**CALIFORNIA GEOLOGICAL SURVEY  
FAULT EVALUATION REPORT FER 253  
SUPPLEMENT NO. 1**

**THE HOLLYWOOD FAULT  
in the Hollywood 7.5' Quadrangle  
Los Angeles County, California**

by  
Janis L. Hernandez  
Engineering Geologist  
November 5, 2014

## **PUBLIC COMMENTS, AND RESPONSE**

**Figure 3** – Study site locality S1-1 indicated in blue shaded area. Boring transect shown as dark blue patterned line. Previous study sites included in the initial FER shown in light green.

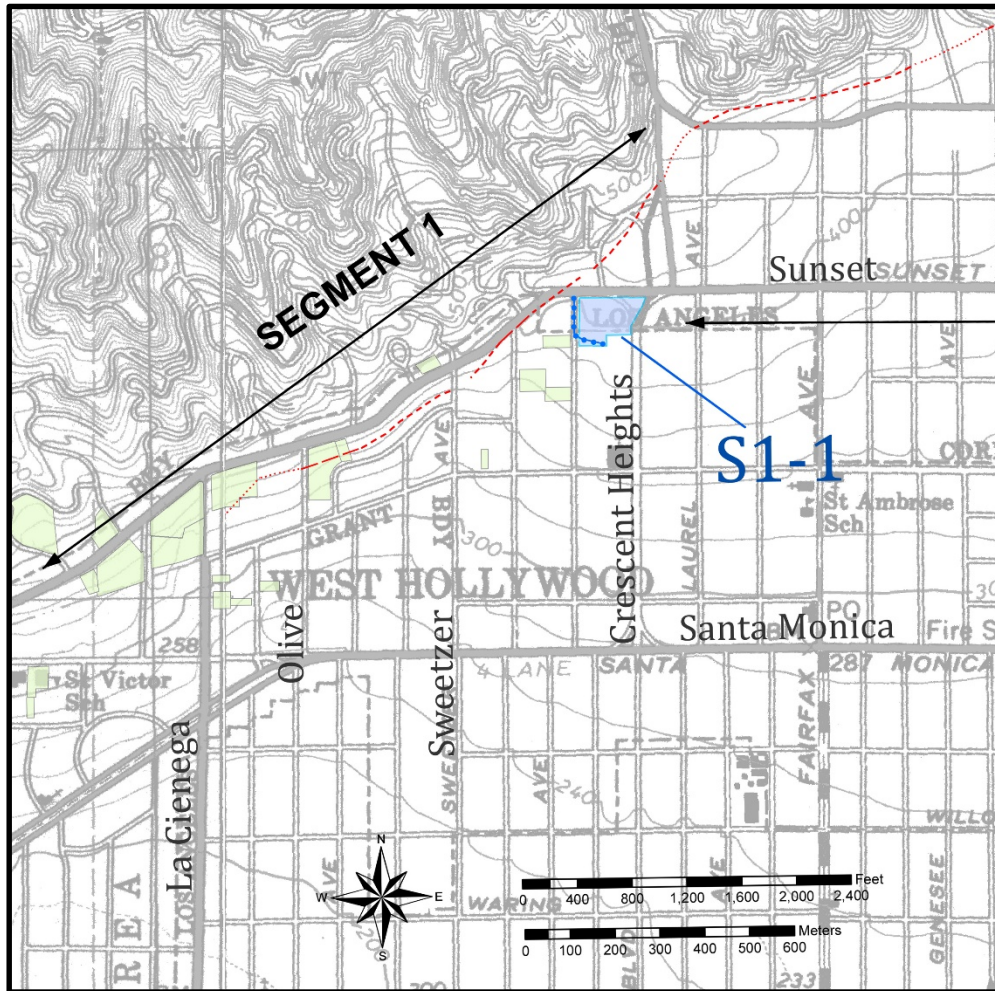
Golder Associates, Inc. (2014a, b) prepared a Surface Fault Rupture Hazard Assessment and Geotechnical Exploration study for a residential and commercial development located on the southwest corner of Sunset Boulevard and Crescent Heights (locality S1-1) as shown on Figure 3. Golder's site evaluation included a CPT transect and hollow stem auger boreholes along the western and southern site boundaries. They interpreted this transect to show continuous alluvial stratigraphy across the site. They reported silts and gravelly sands deposited less than 7 thousand years ago (ka) to depths of about 40 feet. Lower deposits ranged in age from 9 ka to 13 ka at depths of about 60 to 80 feet. They concluded the site has not had major disruption from Holocene faulting.

***The data presented by Golder Associates are consistent with the interpretation presented in the initial FER that the Hollywood Fault lies north of this site as shown on the preliminary Alquist-Priolo Earthquake Fault Zone map.***

**Figure 4** – Index map showing new localities S2-1 and S2-2. Trench locations indicated as orange line segments. Previous studies included in original FER shaded green.

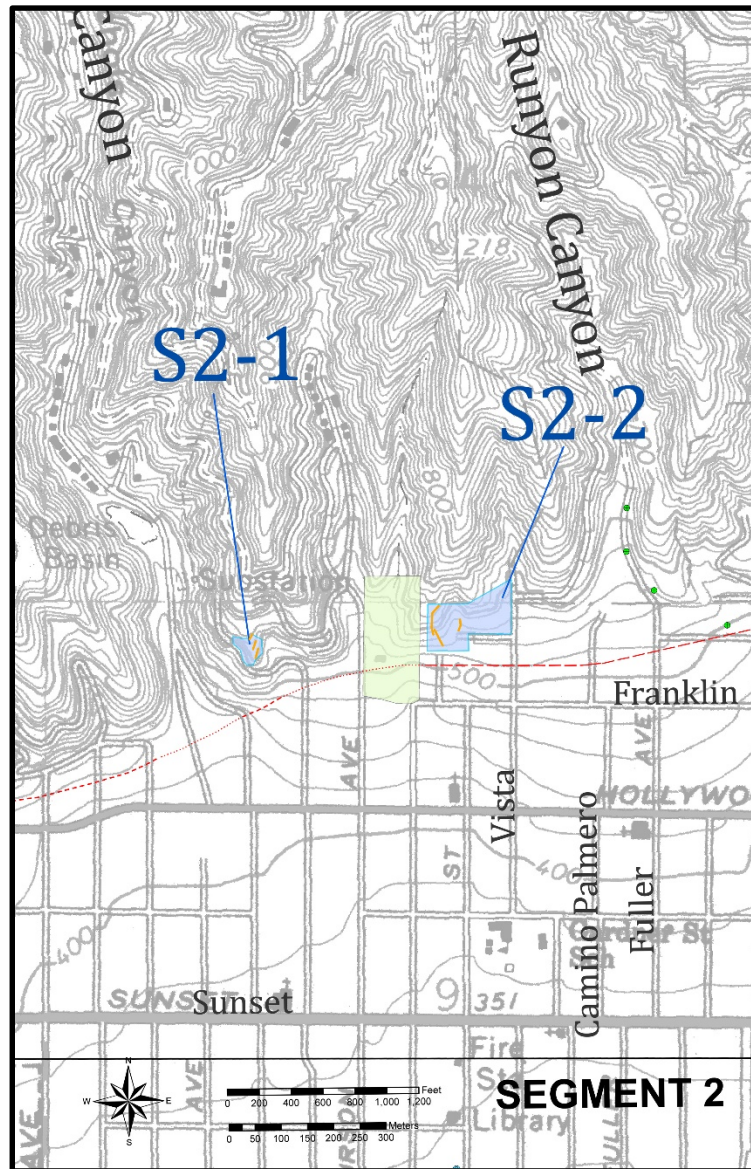
Irvine Geotechnical, Inc. (2014) performed a fault investigation for a residential project located near the base of the Santa Monica Mountains at locality S2-1 (Figure 4). Geologic mapping and shallow trenches were performed as part their study. A geologist for the City of Los Angeles observed the excavation during the study, where un-faulted quartz diorite bedrock was exposed.

Grover Hollingsworth and Associates, Inc. (2014) conducted a fault investigation for a project located along the southern edge of the Santa Monica Mountains, near Runyon Canyon at locality S2-2 (Figure 4). They excavated three fault trenches across the site and observed a thin layer of soil overlying quartz diorite bedrock. Caliche-lined faults were observed in Trenches 1 and 3, but clay gouge and slickensides were not observed in the fault zone. With field review and discussion with the City of Los Angeles geologist, Grover Hollingsworth considered these faults to be pre-Holocene.

**The data presented by Irvine Geotechnical and Grover Hollingsworth and Associates for localities S2-1 and S2-2, respectively, is consistent with the interpretation that no Holocene faults cross these sites north of the fault shown on the preliminary Alquist-Priolo Earthquake Fault Zone map.**

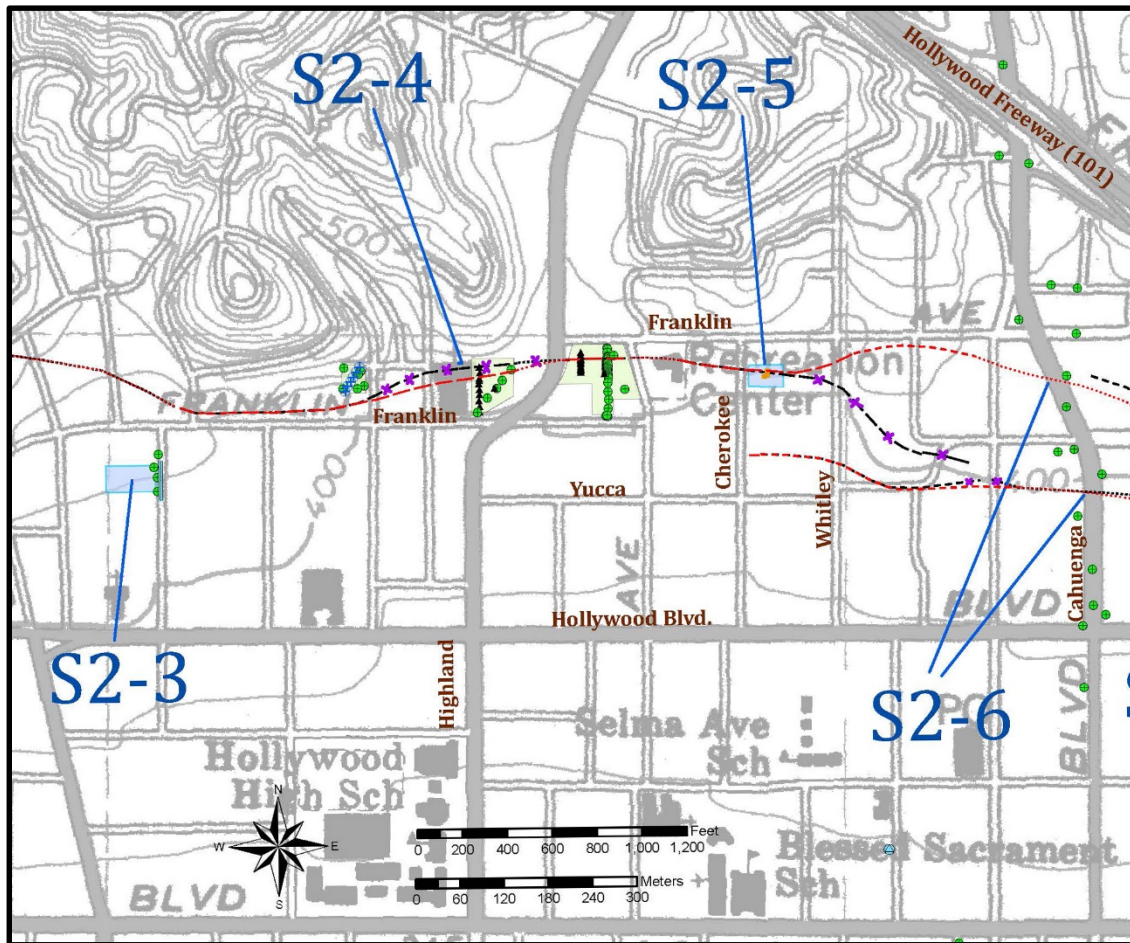
At locality S2-4 (Figure 5), (locality 12 in Hernandez and Treiman, 2014), CGS re-evaluated the fault strands at this site and compared them to the well-defined and well-constrained fault data immediately east of this location (Hernandez and Treiman, 2014), locality 13), as well as new data to the east at locality S2-5 (described below). There were several fault strands indicated in investigations at this site, and the re-assessment of the data led us to select a different strand as the dominant trace.

CGS made observations of two fault trenches at locality S2-5, south of Franklin Avenue and N. Cherokee Avenue (Figure 5). Two separate visits were made to this site by J. Treiman (CGS). The southern trench, first visited on December 31, 2013, exposed southeast dipping Topanga Formation siltstone and sandstone, with interbedded or injected volcanics. No faults were observed in this trench at this time. A northern trench, visited on January 15, 2014, revealed a broad fault zone (about 20 to 30-feet wide) within the Topanga Formation. Bedrock to the north and south of the fault zone dipped moderately to the northeast. Within the fault zone, bedding and shears had an east-west strike with steeply north to vertical dips. Shearing increased toward the northern margin of the zone which had a sharp vertical shear and a soil-filled fissure. The north margin of this soil-filled fissure appeared planar, indicating the soil was faulted, rather than just falling into a shaking-related fracture. A visit to a freshly cleaned exposure at the initial southern trench, also on January 15, showed a shallowly north-dipping shear within the bedrock to the graded surface. Soils overlying the bedrock in the northern trench appeared to be very young. To date no report has been submitted by the owner to the City of Los Angeles or CGS.

***Based on our re-evaluation of these data, we suggest a modification of the fault trace slightly to the south to project through this preferred trace, connecting the well-located fault to the east with better defined scarps to the west.***

***Our observations confirm the location of the northern strand of the Hollywood fault as presented in the initial FER.***

Figure 6 – Cross section from the Metro Red Line subway project. Portion of figure from Converse et al, 1984.

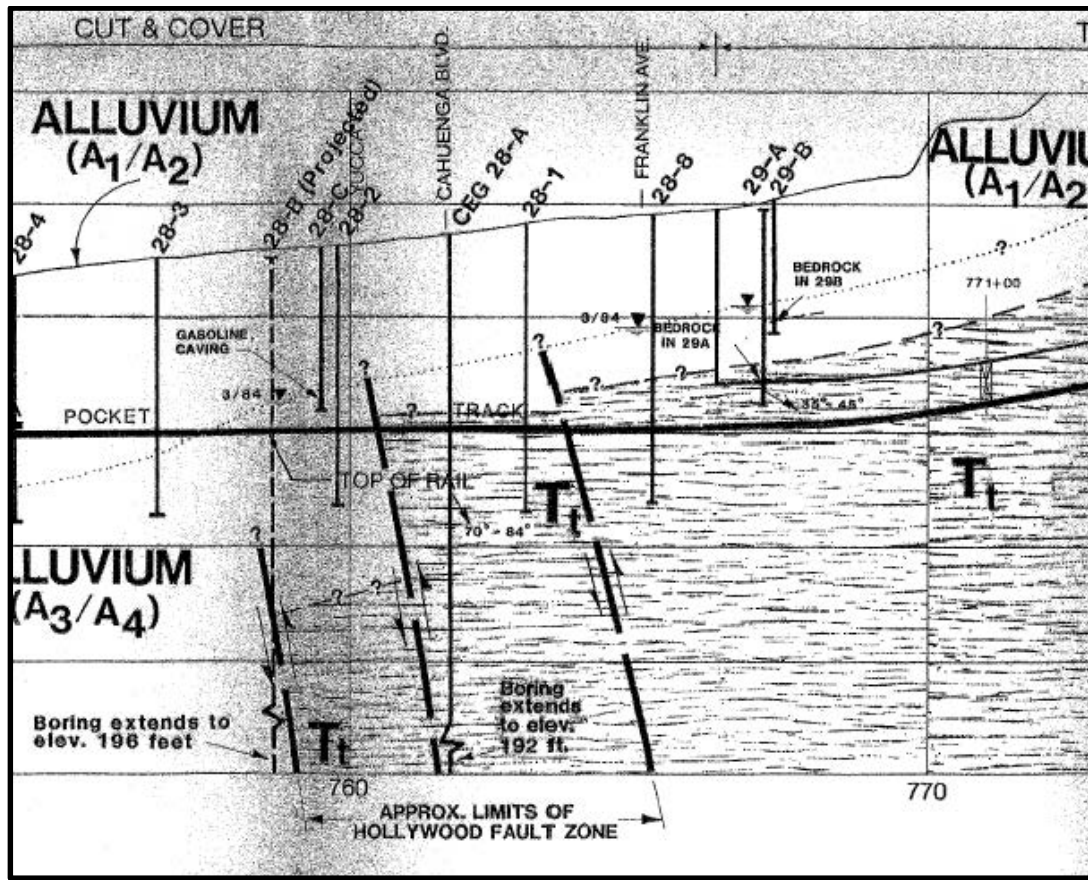
Converse Consultants, Earth Sciences Associates, Geo/Resource Consultants (1984) – locality S2-6 (Figures 5 & 7): CGS acquired a geotechnical report prepared by Converse Consultants et al (1984) for the Metro Rail Red Line Project that was not available for the initial FER (Hernandez and Treiman, 2014). The initial FER relied on data from Converse Consultants et al, (1981, 1983) and Crook and Proctor (1992), and, although the borehole data from the 1984 report were described by Crook and Proctor (1992), the original borehole logs were not in the 1981 and 1983 reports that they reference.

***The data presented by Converse Consultants et al (1984), specifically a cross section (Figure 6 herein) and boring logs, combined with observations of the fault at locality S2-5, support an eastward continuation of the northern fault trace, rather than the southeast trending orientation shown in the initial FER (that was based on Dolan et al., 1997)(Figure 7). We find the stratigraphy within the MTA boreholes reveals lateral discontinuities within the upper alluvial soils above the principal fault strands, in addition to offset bedrock as illustrated in the cross-section (Figure 6). The Converse Consultants data also supports the location of the southern trace of the fault where it crosses Cahuenga Boulevard as shown on the preliminary Alquist-Priolo Earthquake Fault Zone map. Additionally, the cross section shows a third fault that projects toward***

*the ground surface at Yucca Street, roughly between the northern and southern strands (Figure 6). Due to uncertainty as to how the various strands of this complex fault zone connect to the east and west we are only depicting the northern and southern fault traces on the Official Zone map.*

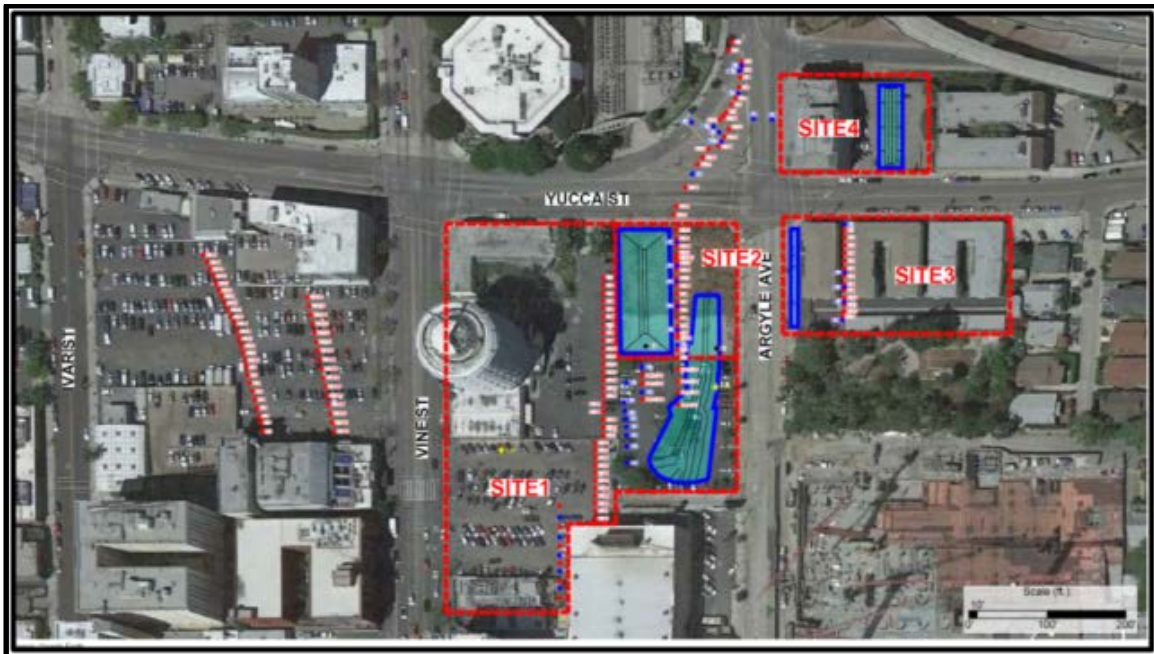
A comment was submitted by Mr. Michael Reader of Group Delta Consultants, Inc. (GDC) on March 13, 2014 to the SMGB for locality S2-8 (GDC Site 2, Figure 8). Mr. Reader stated that although there are mapped locations where the Hollywood Fault is somewhat well-defined, in the area between Cahuenga Boulevard and Gower Street the Hollywood Fault is concealed by alluvial fans, and that no data in this area have located the active trace. He also reported that the geologic community agrees the active trace of the Hollywood Fault lies “somewhere” in this area. However, he questioned the delineation of the zone for this area, with such sparse available data.

A fault study, conducted by Group Delta Consultants, Inc. (2014a) was submitted to the SMGB on May 6, 2014 for locality S2-8 (GDC Site 2, Figure 8). This study included core boring and CPT transects and an approximate 100-foot long, 30 foot deep trench on the western portion of the site. GDC reported that they found no evidence for faulting in the Holocene units on this site. The study also reported age estimates of weathered soil horizons at two locations within the trench, prepared by Dr. Roy Shlemon, and included test results from two charcoal samples submitted for C14 dating.

A second Fault Activity Report was submitted by GDC for locality S2-8, dated September 3, 2014 (Group Delta, 2014b). This investigation consisted of additional CPT and core borings from adjacent sites in the vicinity, and an additional trench located on the eastern portion of the site that also extended south into GDC Site 1 (locality S2-9). During this second investigation, GDC reported a bedding plane fault underlies the site, where they concluded this fault is overlain by a buried paleosol “indicative of about 30 ka of weathering.” This trench was excavated in response to comments by the City of Los Angeles noting that faulted Pleistocene sediments were found directly across the street to the east (GDC, Site 3; locality S2-11). Within this eastern trench at locality S2-8, Argyle Channel deposits were exposed, underlain by mudflow deposits (previously referred to by GDC as the clayey sand or “basal clay” unit). Underlying the mudflow deposits they reported well-consolidated older alluvial debris flow deposits that are dipping gently to steeply to the south. C14 dates near the base of the Argyle Channel deposits were reported at ~4.1 to 4.3 ka. (Group Delta, 2014a, 2014b). The soil ages within the trench were derived from soil profile descriptions from R. Shlemon. GDC concluded that folding and related slip observed in their trench occurred prior to deposition of the mudflows, capped by a remnant buried paleosol of about 30 ka, and are overlain by the unbroken, estimated ~12 ka Argyle Channel deposits.

***The initial FER (Hernandez and Treiman, 2014) provides strong evidence that the fault is well-defined to the west of the Yucca Street/Argyle Avenue area. Reasonable projection of the Hollywood Fault in this area was inferred based on supportive evidence to the west, geomorphic interpretation, and limited subsurface data. There is also good evidence the fault continues to the east, suggesting that a continuous zone of faulting extends across the map. The purpose of the map is to require investigations, like those Mr. Reader refers to in the Yucca Street/Argyle Avenue area, to ensure fault rupture is not a hazard to human lives and habitable structures.***

***The data presented in the GDC report appear to be consistent with the interpretation that the Argyle Channel deposits are of Holocene age. However, multiple C14 samples GDC reported within their trenches near the base of the Argyle Channel, are only ~4.3 ka and thus the channel deposits do not represent the complete Holocene record. We consider the Argyle Channel deposits to be approximately 6 ka, based on C14 data throughout the two trenches, and related soil development. The interpretation that the underlying clayey deposit is pre-Holocene appears to be consistent with the reported data. Detailed analysis of the soil profile development was prepared by G. Seitz, of CGS, and is included in Appendix A of this supplement. This analysis includes further comments regarding the reported age classification of the Argyle Channel deposits, and underlying clayey sand unit.***

*The data presented in the GDC report regarding faulting of these deposits is also open to alternate interpretations. The trench log and correlation by GDC show that Argyle Channel deposits are unfaulted across much of the site. CGS performed a field review of the west trench on two occasions, the first was not extensive enough to verify all of the consultant's conclusions due to safety concerns, however a subsequent visit afforded the opportunity to view the clayey sand deposits and relative soil development at the base of the trench. Our review of the CPT and core boring data for GDC Site 2 finds the Argyle Channel sand unit appears to be continuously correlated between borings and CPT tests, however the underlying clayey sand unit is shown to be discontinuous across portions of the site. Our review further notes the cross sections illustrated by GDC favor the CPT correlations, where core boring data in some areas does not directly support their stratigraphic interpretation.*

*Based on this new trench data, as well as other data, we have relocated the northern fault strand to project along Yucca Street toward the north. The southern fault strand is also modified in this area based on data from locality S2-9 (GDC Site 1), described below.*

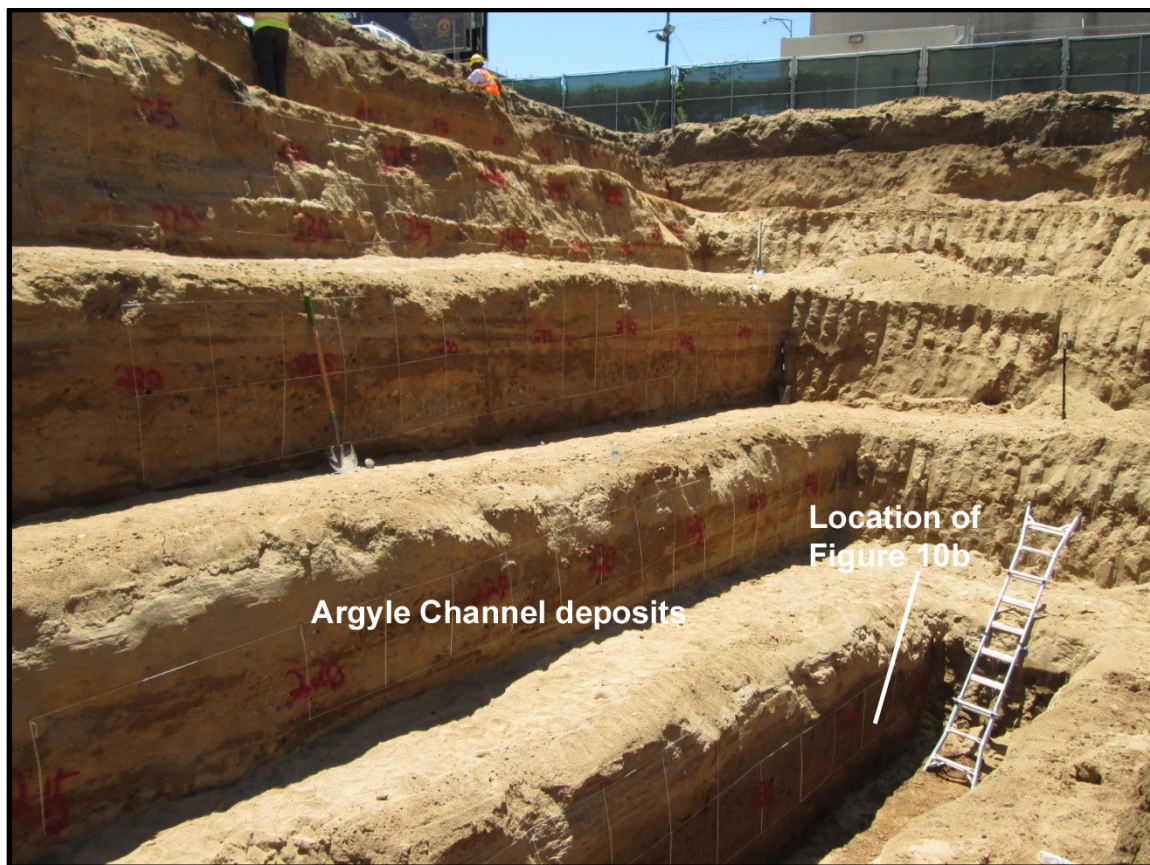
***CGS was invited to the site for periodic trench review between June 30, 2014 and July 11, 2014, where we observed unbroken Argyle Channel deposits overlying an older unbroken unit that was tentatively correlated by GDC staff to mudflow deposits observed to the north. In the northern portion of Site 1 near the boundary with Site 2, the late-Pleistocene mudflow unit appears to be draped over the underlying folded debris flow units, and what may be the same unit appears near-horizontal as it extends to the southern end of the trench (Figure 10a).***

**We received no logs of this part of the trench to clarify these relationships.**

**Figures 10a, 10b show the stratigraphy in the south end of the trench. Our review of the CPT data for this site, and some earlier core borings (from GDC Site2) indicates a discontinuous south-dipping Quaternary stratigraphic section, with a prominent stratigraphic break toward the southern end of the property indicative of a fault. The orientation of this break appears to be north-dipping, projects upward toward the ground surface near the southern property boundary (south of the trench exposure), is in alignment with the fault scarp located north of Carlos Avenue immediately to the east, and is in alignment with an inferred fault trace from the Langan data west of Vine Street (locality S2-7) to the west. On the basis of these observations, the southern trace of the Hollywood Fault has been moved to the southern boundary of locality S2-9, just south of the trench exposure.**

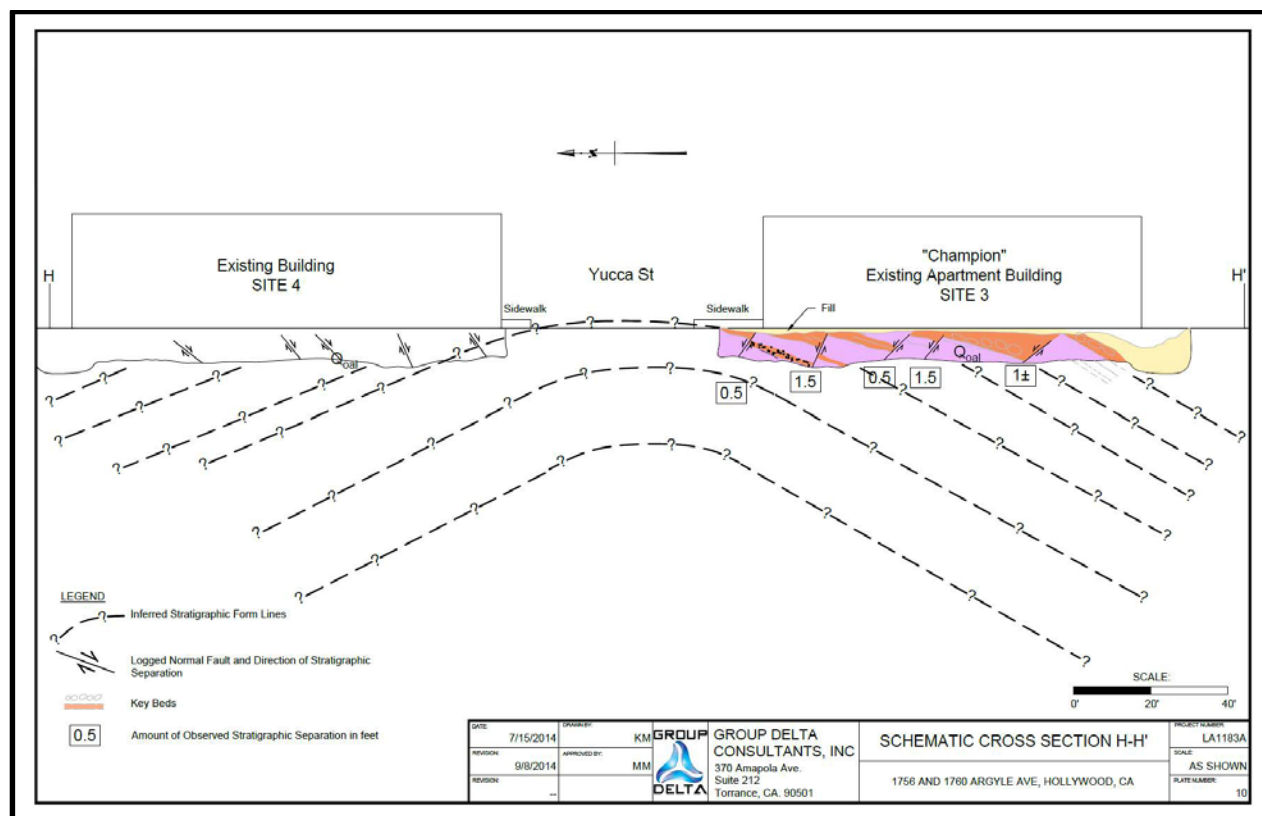
At locality S2-11, (GDC Site 3, Figure 8), Group Delta (2014c) reported the site is underlain by fill materials and older alluvial debris flows, which in turn are underlain by Modelo Formation. Their site investigation included both CPT and core borings, and an approximate 8-foot deep trench on the west side of the site. GDC reported the older alluvial unit consists of Pleistocene debris flows, and state that this unit is faulted. They associated this fault with a localized west-northwest oriented anticline, which extends north to GDC Site 4, as shown in their cross-section (Figure 11). They interpret these features to be due to regional transpression and not to seismogenic faults. They report the age of the faulting at this site is older than 35 ka based on unbroken mudflow deposits found to the west at Site 2.

***The data presented in the GDC report is consistent with the interpretation that the deposits are of Pleistocene age although it is unclear why these “debris flow” deposits are differentiated from the similarly comprised and deformed older alluvial fan unit exposed and described at site 2.***

**Interpretation that the faults are local bending moment faults is not consistent with CGS field observations within the trench. CGS noted a significant lack of correlation across the southernmost fault, and that thickness of units changed across most of the faults, which indicates a component of lateral displacement (Figure 12). The southernmost fault appeared to be a prominent fault, as correlative units across the fault were not found, suggesting this fault trace may have seen the most displacement. No evidence for, or against, Holocene faulting was reported on this site because Holocene deposits, if present, were likely removed during site development.**
